Re: *Invenergy Docket No. SB-2015-06*

**INVENERGY THERMAL DEVELOPMENT LLC'S RESPONSES TO
THE RHODE ISLAND DEPARTMENT OF ENVIRONMENTAL MANAGEMENT'S
FIRST SET OF DATA REQUESTS**

**CLEAR RIVER ENERGY CENTER
FUEL OIL STORAGE TANK
PRELIMINARY CONCEPTUAL CATHODIC PROTECTION
PLAN, SECTION AND DETAILS**

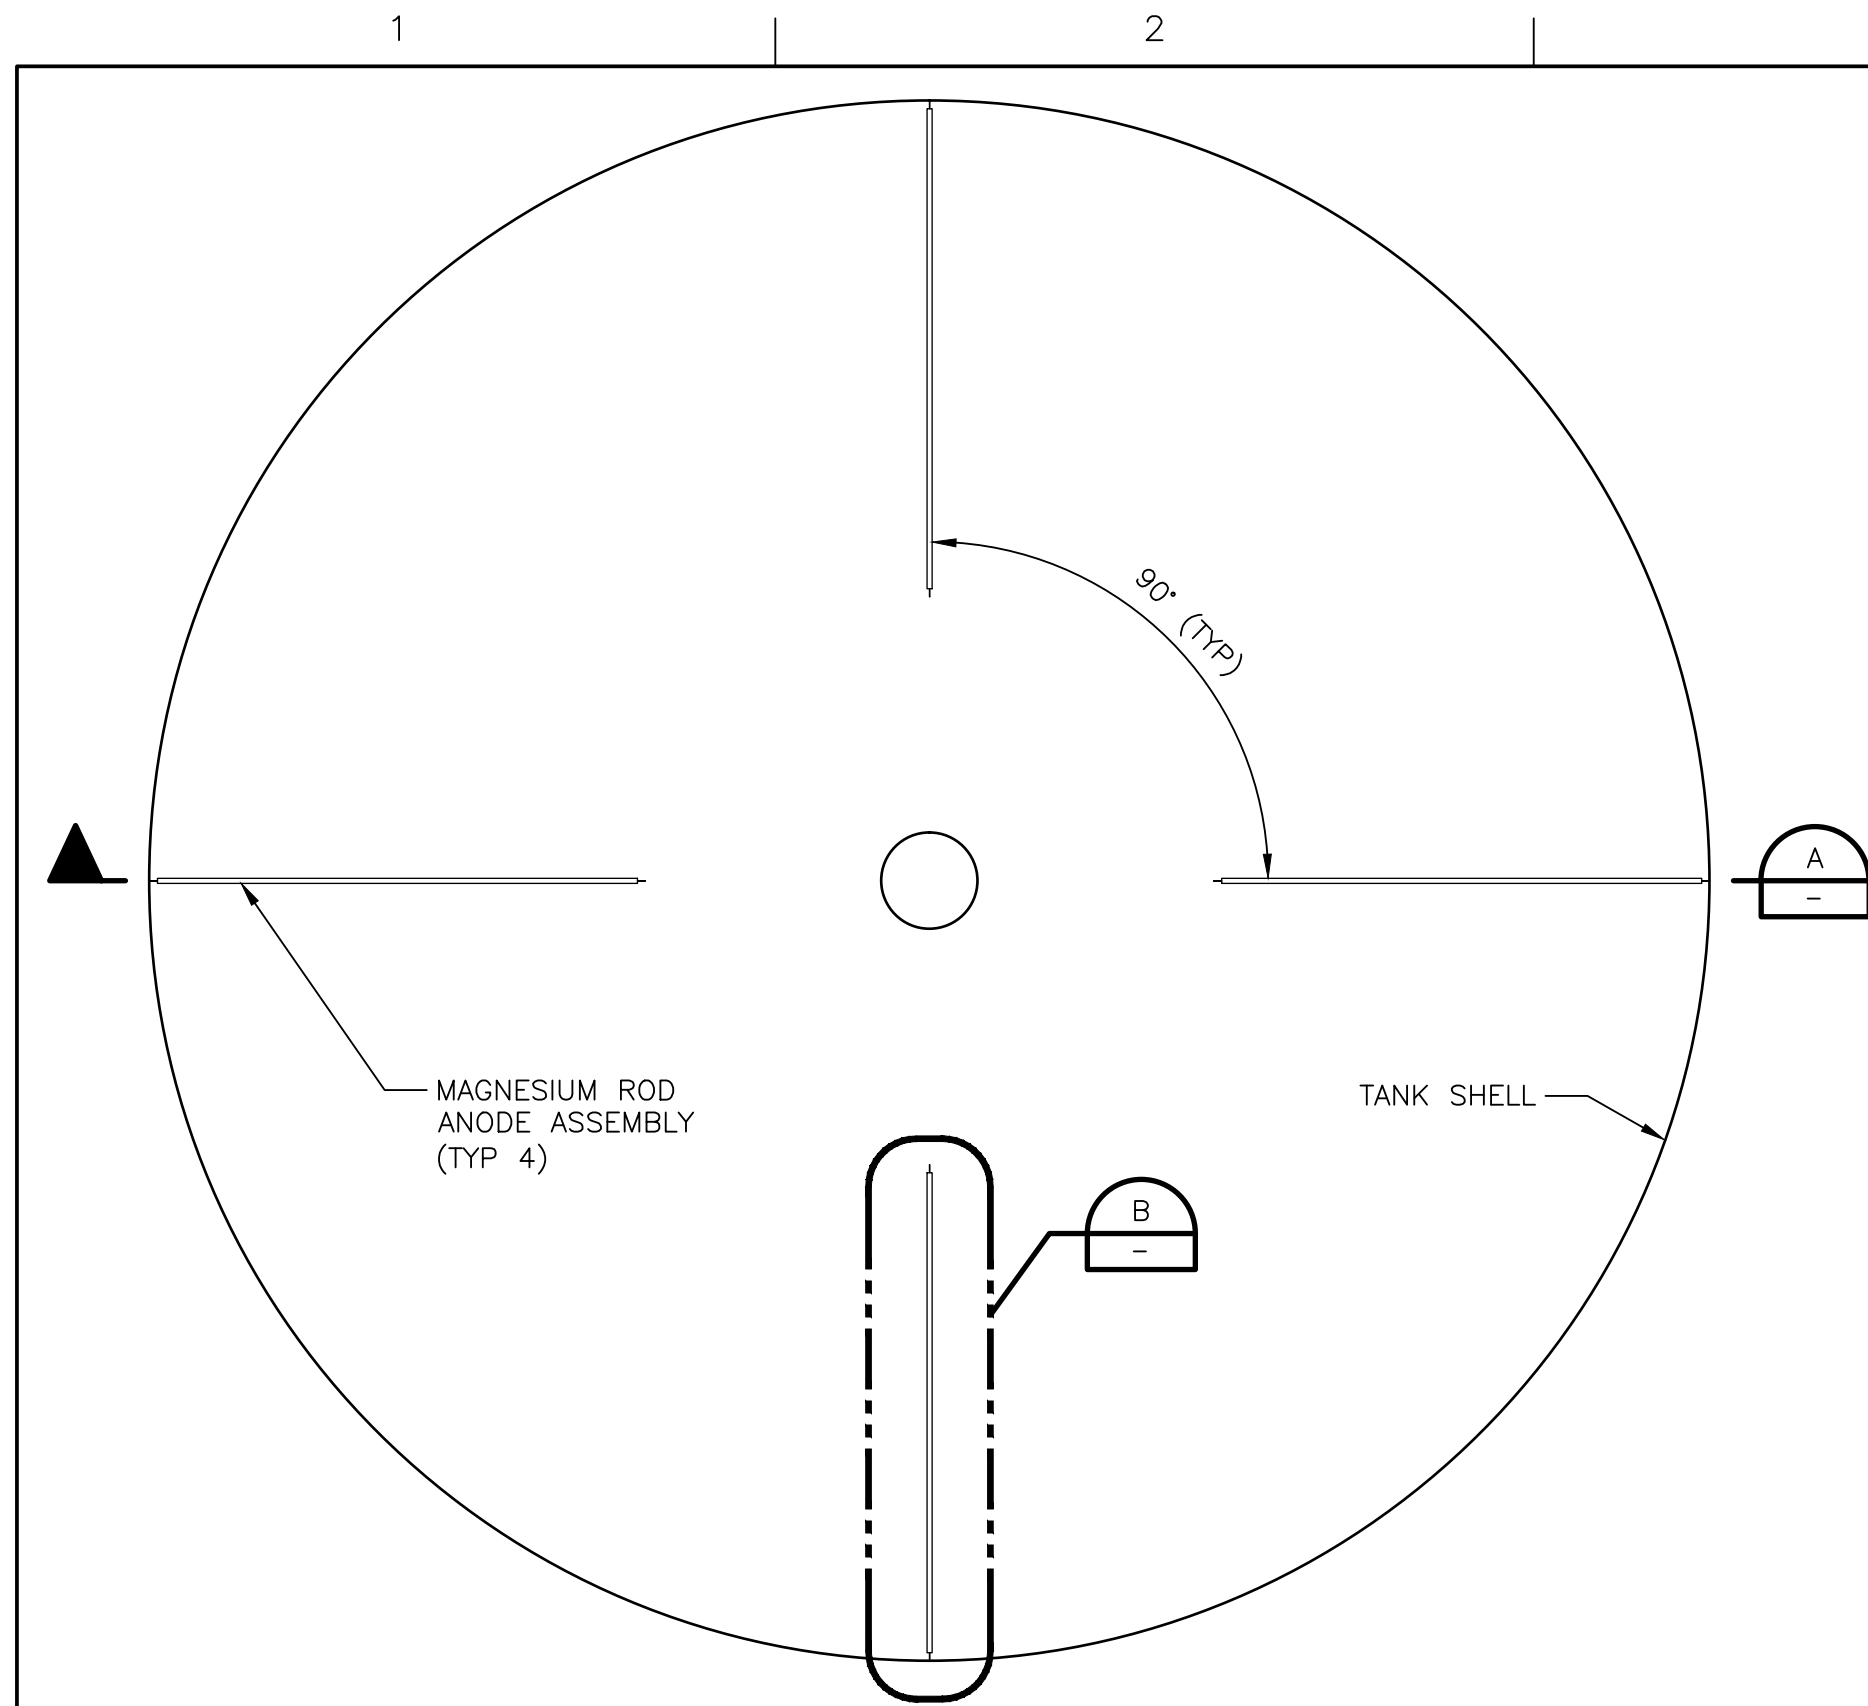
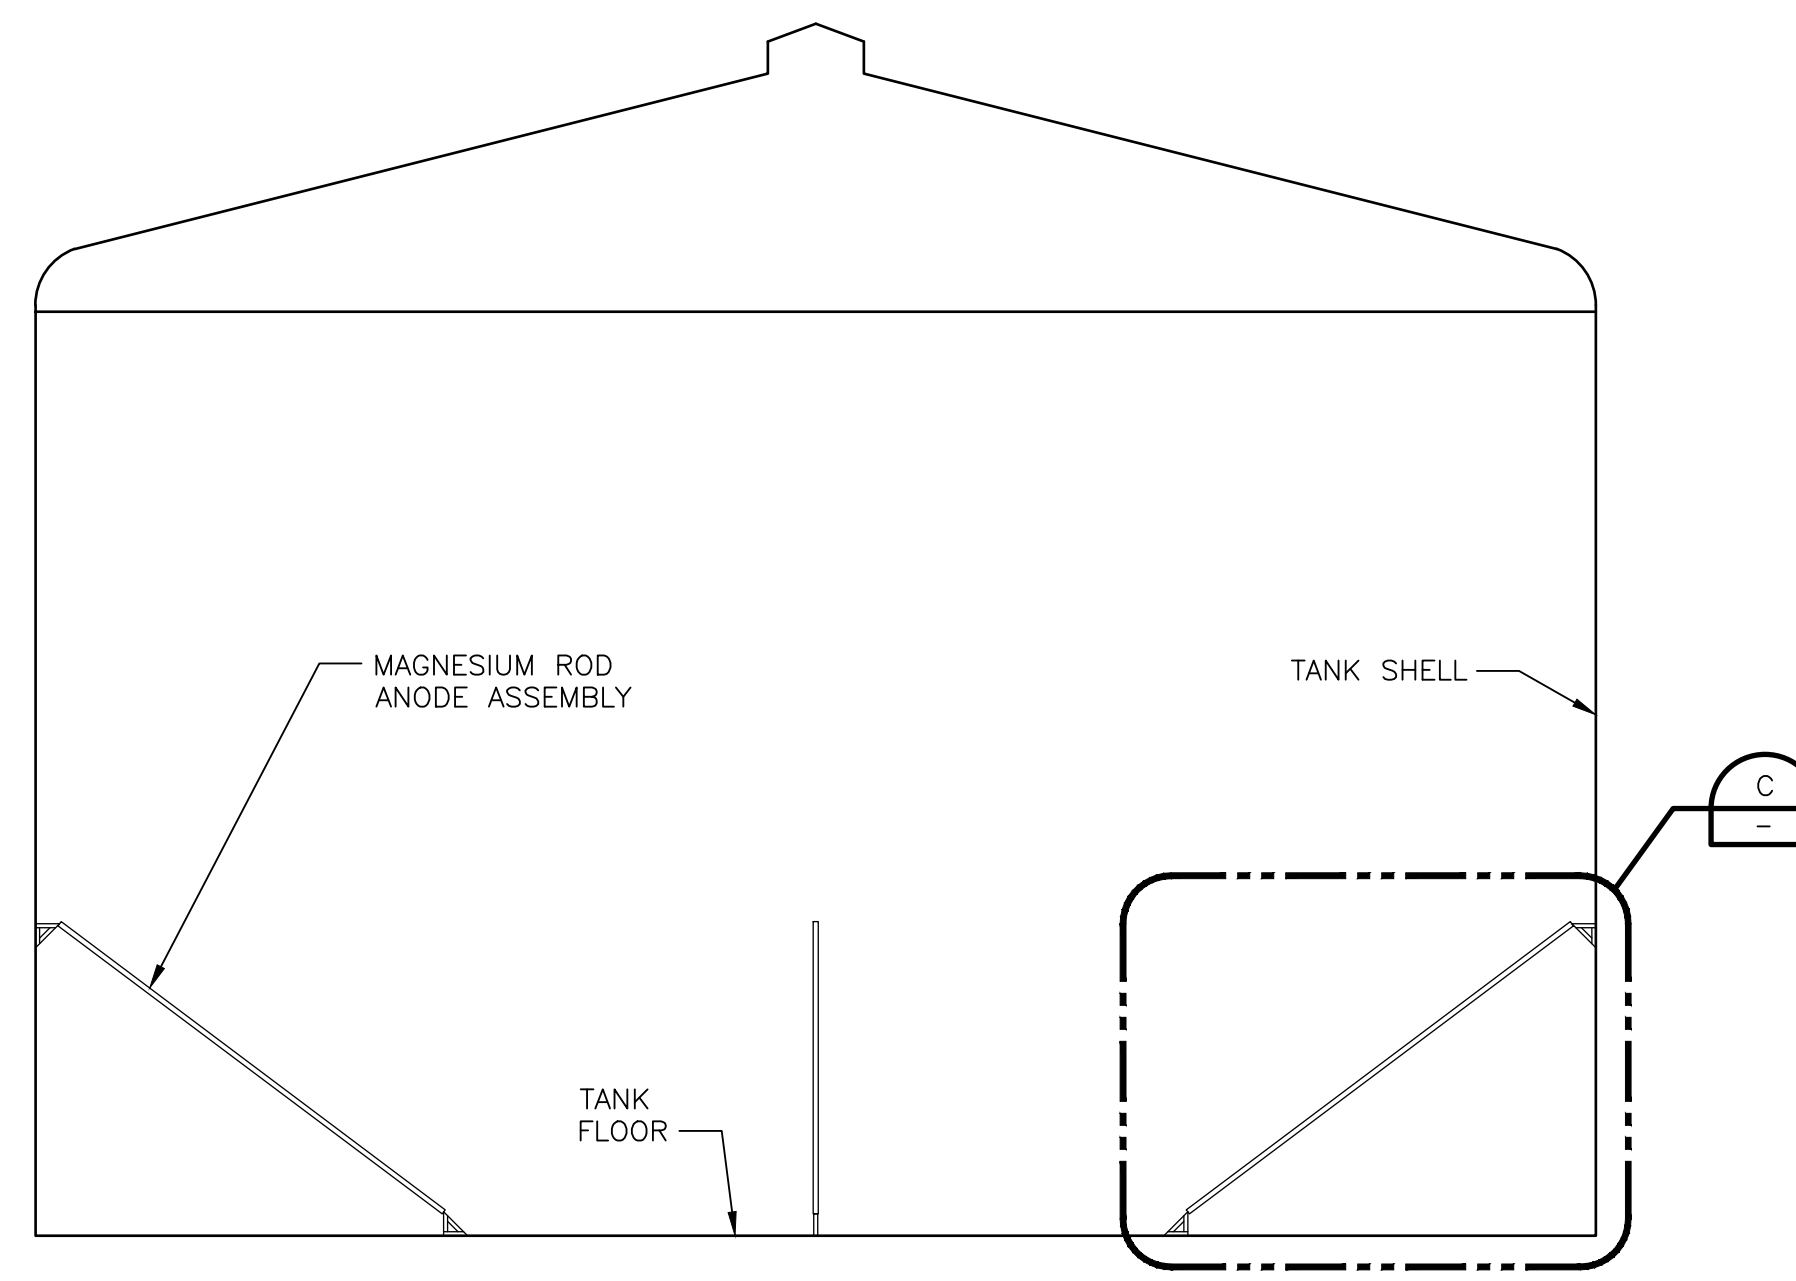
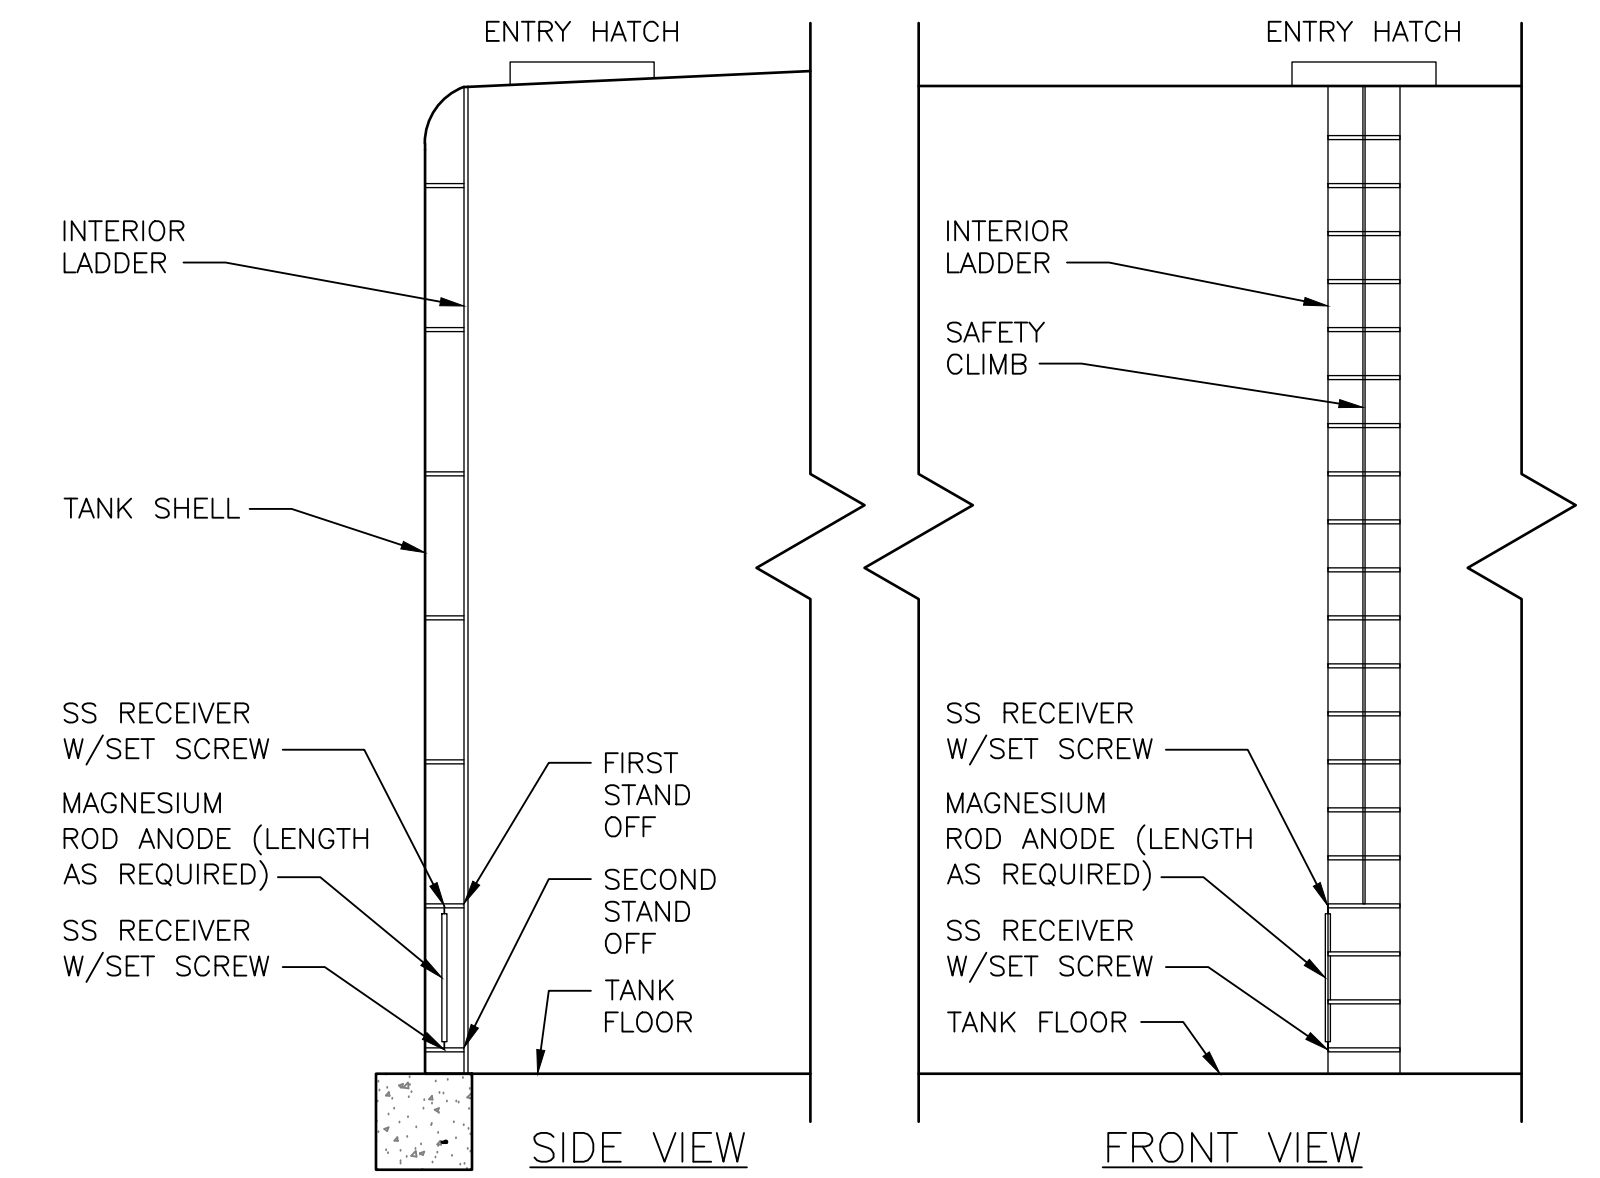
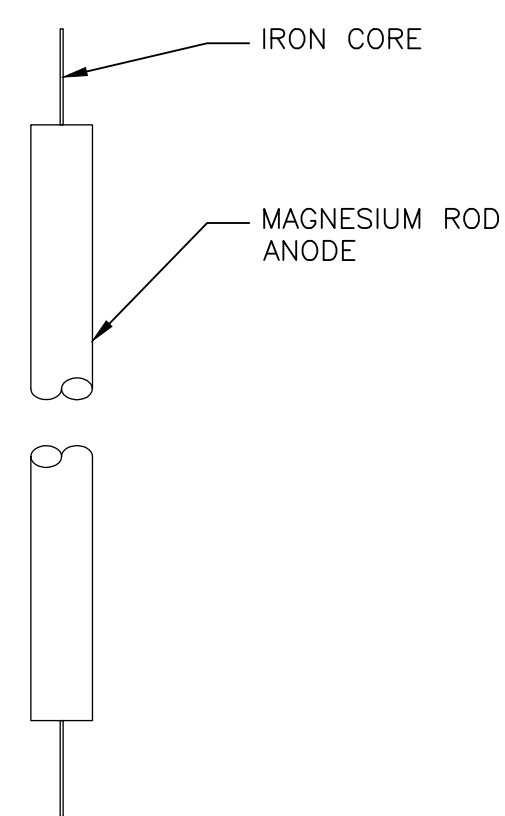
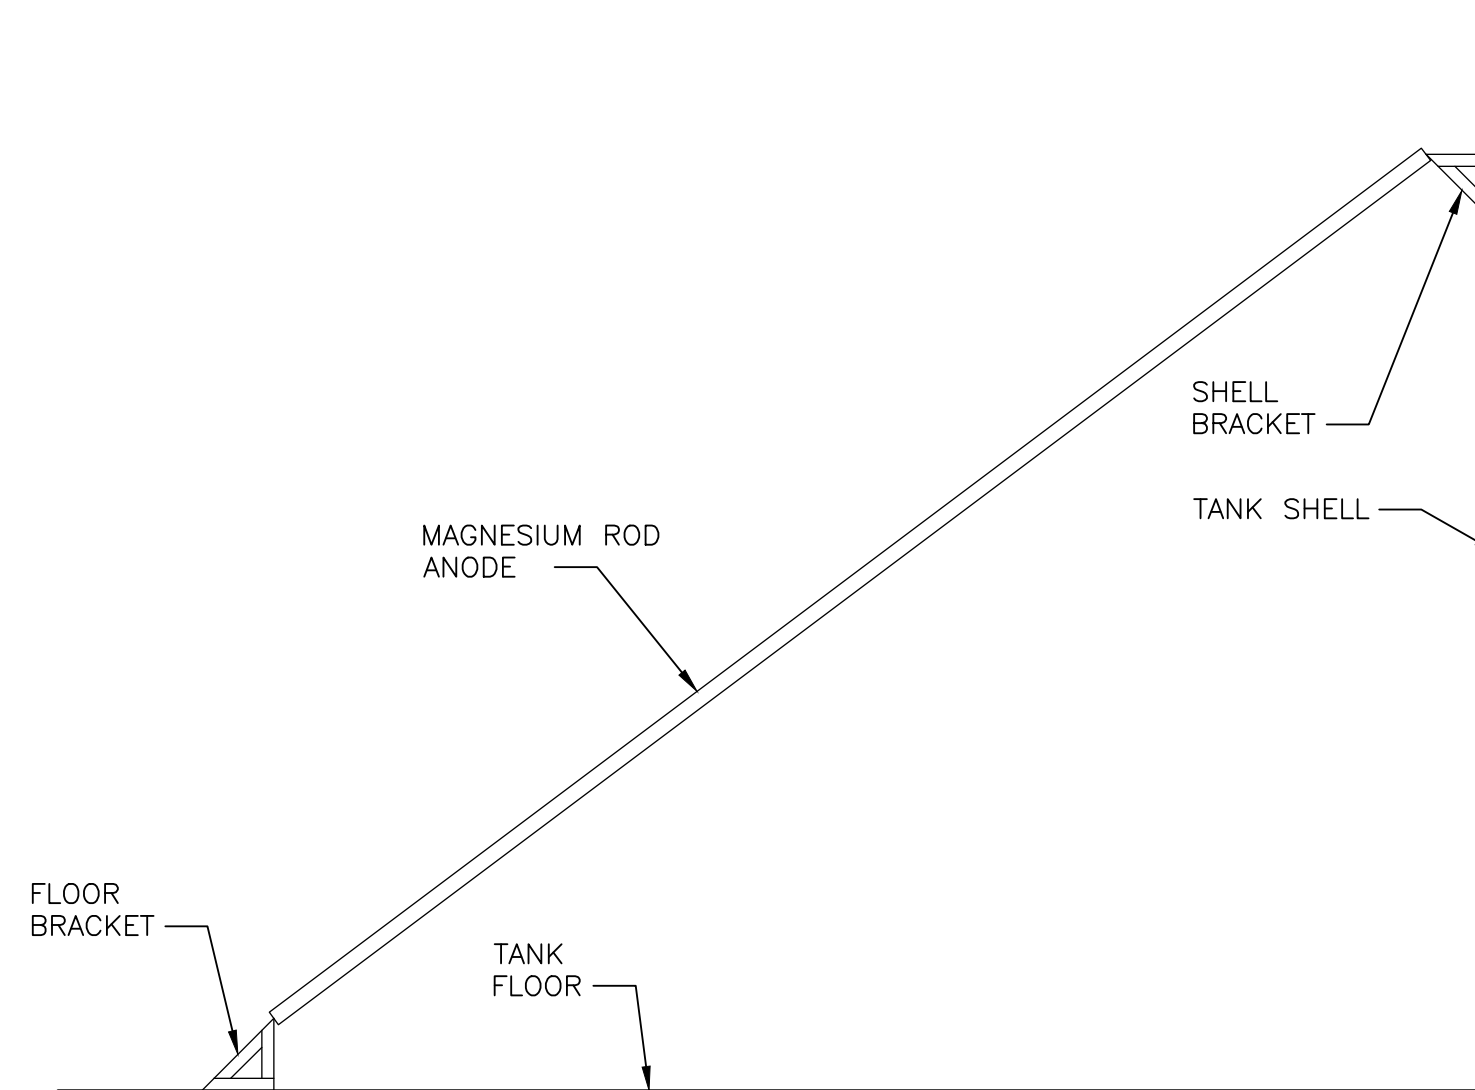
1-10 Please provide a diagram for cathodic protection for tank bottoms that rest on or in the ground. If required, the cathodic protection system must be designed to provide a minimum of 30 years of protection and installation must be supervised by a qualified engineer or corrosion specialist. The cathodic protection system also must have a monitor which enables the owner or operator to check on the adequacy of the cathodic protection. *See OPC Regulations Section 10(i)(2).*

RESPONSE: 1-10 The above ground carbon steel fuel oil storage tank will either be installed on top of a reinforced concrete pad or a ring type foundation will be provided for the tanks.

When the tanks are installed on a concrete pad, the tank bottom does not come in contact with the soil and therefore cathodic protection would not be required. If a ring type foundation is designed, the bottom off the tank will come in contact with supporting soil/sand and will require cathodic protection.

Foundation type and engineering, including preparation of engineering drawing, will be performed during the detailed design phase of the project. If cathodic protection is required, it will be designed for 30 year life. Design and installation will be supervised by a qualified engineer or corrosion specialist. The cathodic protection system will include a monitoring system to test the function of the system.
